PEER REVIEW/CONCURRENT EVALUATION OF DPR AND BID PROCESS MANAGEMENT FOR THE MUMBAI COASTAL ROAD PROJECT

PHASE 1 REPORT

February 2016

Frischmann Prabhu

Figure 3-17 Amarson Garden Interchange (Bhulabhai Desai Road)

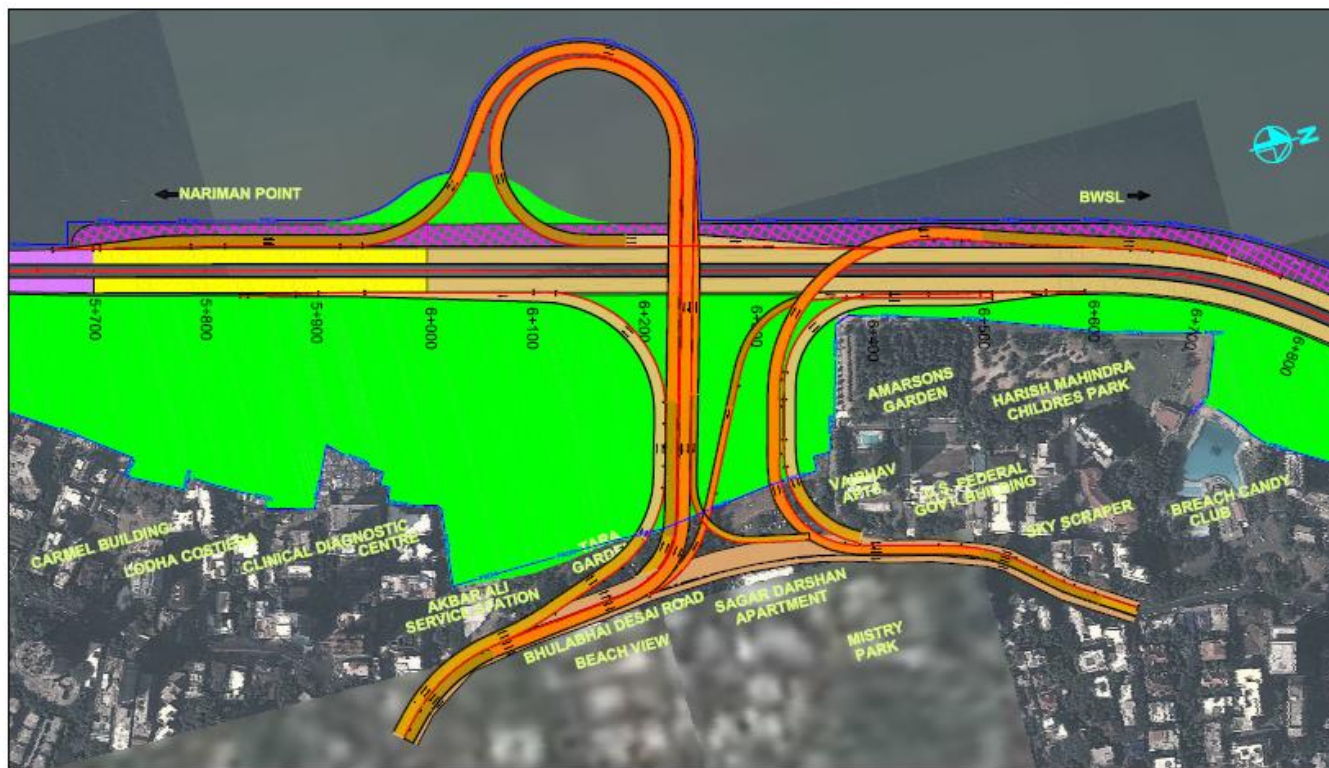
AMARSON GARDEN INTERCHANGE (BHULABHAI DESAI ROAD)				
Sr. No.	Report / Drawing Reference	Element	Observation / Comments	Recommendation / Suggestion
1	8098/E/DD- 1110 (R0) to 1117A (R0) and Note: 8098/E/DN-7	Location	The ideal minimum spacing between interchanges shall be 3 km in accordance with clause 3.3.5 of IRC SP 99. However, the location of this interchange is in order in view of the traffic dispersal.	
2	8098/E/DD- 1110 (R0) to 1117A (R0) and Note: 8098/E/DN-7	Traffic Dispersal	The provision has been made for traffic dispersal to and fro from Coastal road except the entry to coastal road from US Federal Govt. building towards Nariman point not provided. The requirement of this arm should be arrived at based peak hour traffic. The DPR report provides turning ADT.	Peak hour turning movement should be used to arrive at the requirement of different arms and their capacities of Interchange.

AMARSON GARDEN INTERCHANGE (BHULABHAI DESAI ROAD)				
Sr. No.	Report / Drawing Reference	Element	Observation / Comments	Recommendation / Suggestion
	Note: 8098/E/DN-7		(table 3.2 IRC SP 99), Arm 4 – Deceleration length is less than required (table 3.3 IRS SP 99)	drawings for better clarity.
5	8098/E/DD- 1110 (R0) to 1117A (R0) and Note: 8098/E/DN-7	Tie-in with Bhulabhai Desai Road	It is not clear from layout if the interchange ramps are properly tie-in to Bhulabhai Desai road. The existing space availability for landing the elevated ramp may create constraint and congestion on existing road space.	DPR consultant to clarify if sufficient space is available for tie-in. Provide 2-3 cross section at critical locations showing existing road and other feature with constraints if any.
6	8098/E/DD- 1110 (R0) to 1117A (R0) and Note: 8098/E/DN-7	All Tie-ins	Tie-in shall be matched properly. The tie-in shall be in same design plane as per main carriageway sufficiently covering the acceleration and deceleration lengths. Design contours shall be made available for further review.	DPR consultant to confirm.

7	8098/E/DD- 1110 (R0) to 1117A (R0) and Note: 8098/E/DN-7	Visibility	Visibility report / envelopes not available for review. SSD and Decision sight distance (DSD) (as per table 2.7 and 2.8 of IRC SP 99) shall be available.	DPR consultant to provide visibility report and confirm availability of SSD/DSD considering all the hazards e.g. kerb, parapets etc. Widening shall be incorporated wherever necessary or appropriate mitigation measures shall be suggested and incorporated in design.

AMARSON GARDEN INTERCHANGE (BHULABHAI DESAI ROAD)				
Sr. No.	Report / Drawing Reference	Element	Observation / Comments	Recommendation / Suggestion
8	8098/E/DD- 1110 (R0) to 1117A (R0) and Note: 8098/E/DN-7	Turning movement	Width of loops and ramps on curves needs to be checked for manoeuvring of large vehicles.	DPR consultant shall confirm conflict free manoeuvring based on Auto Turn layout considering the highest possible rigid vehicle length likely to use the interchange. Deficient bends shall be widened appropriately.
9	8098/E/DD- 1110 (R0) to 1117A (R0) and Note: 8098/E/DN-7	Crossfall/ Superelevation	The location of tie-in and application of super elevation are likely to cause flat spot issues which are undesirable as they have potential to cause accidents.	Flat spot shall be avoided. DPR consultant shall provide flat spot report and confirm there are no flat spot when checked for desirable gradient of 0.5%.

Figure 3-20 Bandra Worli Sea Link Interchange (Bandra End)

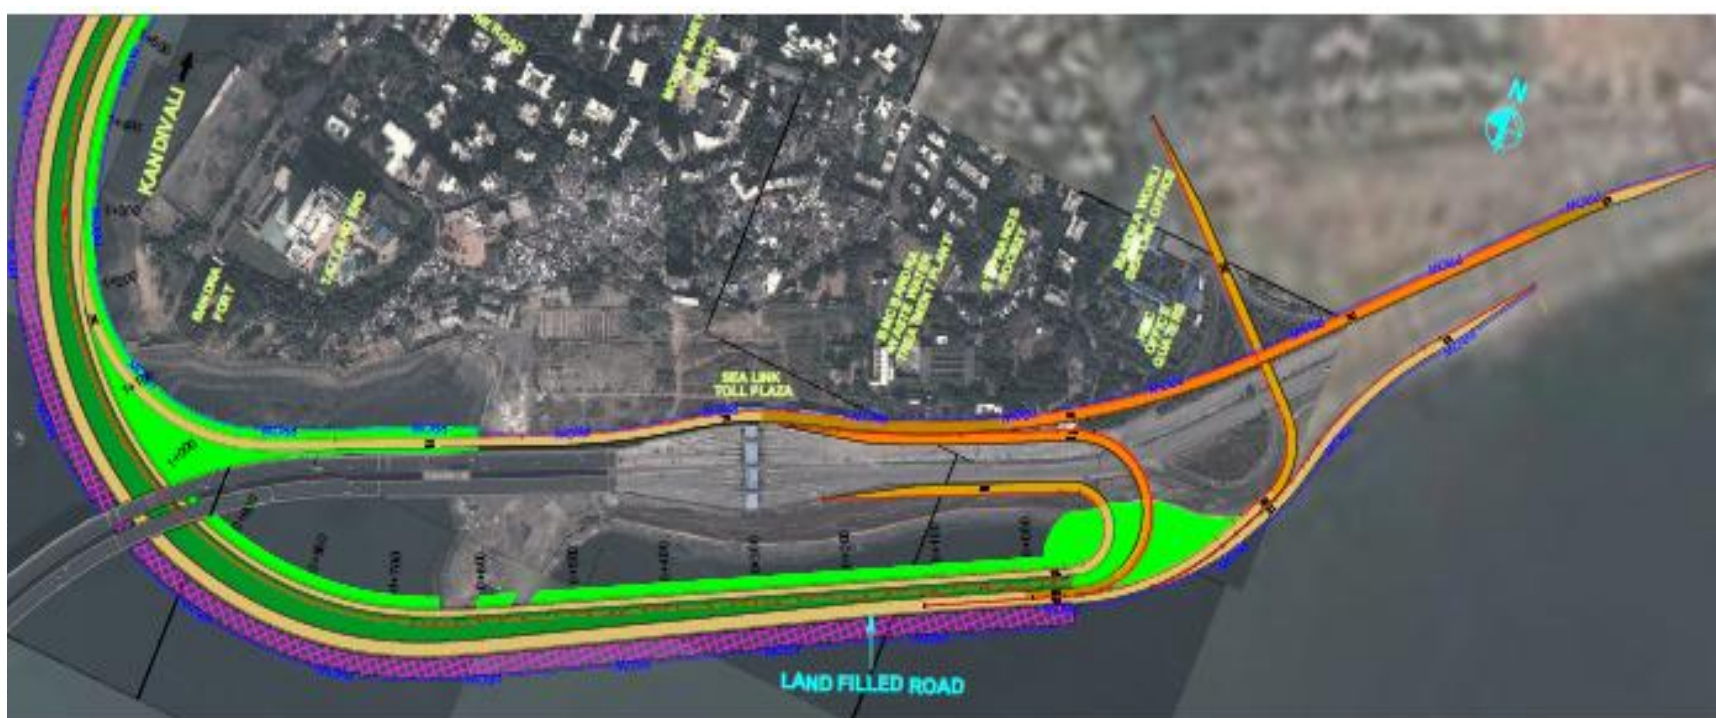
BANDRA WORLI SEA LINK INTERCHANGE (BANDRA END)				
Sr. No.	Report / Drawing Reference	Element	Observation / Comments	Recommendation / Suggestion
1	8098/E/DD- 1140 (R0) to 1145A (R0) and Note: 8098/E/DN-7	Location	The location of this interchange is in order in view of the traffic dispersal. The DPR report provides turning ADT.	Peak hour turning movement should be used to arrive at the requirement of different arms and their capacities of Interchange.
2	8098/E/DD- 1140 (R0) to 1145A (R0) and Note: 8098/E/DN-7	Traffic Dispersal	The provision has been made for traffic dispersal to and fro from Coastal road.	
3	8098/E/DD- 1140 (R0) to 1145A (R0) and Note: 8098/E/DN-7	Improvement at Interchange	TOR envisage to check the feasibility of avoiding the alignment of coastal road through sea link toll plaza.	Three numbers of alternative Interchange layouts are suggested by avoiding the alignment through toll plaza for North-South traffic. Each of the alternatives has been described along with merits and demerits in sub-sections below. It is however to be noted that avoiding the present sea link is unlikely without a separate parallel sea link or an underground tunnel.

BANDRA WORLI SEA LINK INTERCHANGE (BANDRA END)				
Sr. No.	Report / Drawing Reference	Element	Observation / Comments	Recommendation / Suggestion
	Note: 8098/E/DN-7			followed. The geometry should be designed with respect to the design speed.
5	8098/E/DD- 1140 (R0) to 1145A (R0) and Note: 8098/E/DN-7	Acceleration and Deceleration Lane	Insufficient lengths are provided for acceleration and Deceleration lanes. For e.g Arm 4, 5,— it appears acceleration provided is less than required (table 3.2 IRC SP 99)	In the interest of road safety, sufficient acceleration and deceleration length shall be provided along with appropriate nose lengths. Taper length shall be indicated on drawings for better clarity.
6	8098/E/DD- 1140 (R0) to 1145A (R0) and Note: 8098/E/DN-7	Tie-in with existing Road	It is not clear from layout if the interchange ramps are properly tie-in to existing Road. The existing space availability for landing the elevated ramp may create constraint and congestion on existing road space.	DPR consultant to clarify if sufficient space is available for tie-in. Provide 2-3 cross section at critical locations showing existing road and other feature or constraints.

7	8098/E/DD- 1140 (R0) to 1145A (R0) and Note: 8098/E/DN-7	All Tie-ins	Tie-in shall be matched properly. The tie-in shall be in same plane as per main carriageway sufficiently covering the acceleration and deceleration lengths. Design contours shall be made available for further review.	DPR consultant to confirm.
8	8098/E/DD- 1140 (R0) to 1145A (R0) and	Visibility	Visibility report / envelopes not available for review. SSD and Decision sight distance (DSD) (as per table 2.7 and 2.8 of	DPR consultant to provide visibility report and confirm availability of SSD/DSD considering all the hazards e.g

BANDRA WORLI SEA LINK INTERCHANGE (BANDRA END)				
Sr. No.	Report / Drawing Reference	Element	Observation / Comments	Recommendation / Suggestion
	Note: 8098/E/DN-7		IRC SP 99) shall be available.	kerb, parapets etc. Widening shall be incorporated wherever necessary or appropriate mitigation measures shall be suggested and incorporated in design.
9	8098/E/DD- 1140 (R0) to 1145A (R0) and Note: 8098/E/DN-7	Turning movement	Width of loops and ramps on curves needs to be checked for manoeuvring of large vehicles.	DPR consultant shall confirm conflict free manoeuvring based on Auto Turn layout considering the highest possible rigid vehicle length likely to use the interchange. Deficient bends shall be widened appropriately.
10	8098/E/DD- 1140 (R0) to 1145A (R0) and Note: 8098/E/DN-7	Crossfall / Superelevation	The location of tie-in and application of super elevation are likely to cause flat spot issues which are undesirable as they have potential to cause accidents.	Flat spot shall be avoided. DPR consultant shall provide flat spot report and confirm there are no flat spot when checked for desirable gradient of 0.5%.
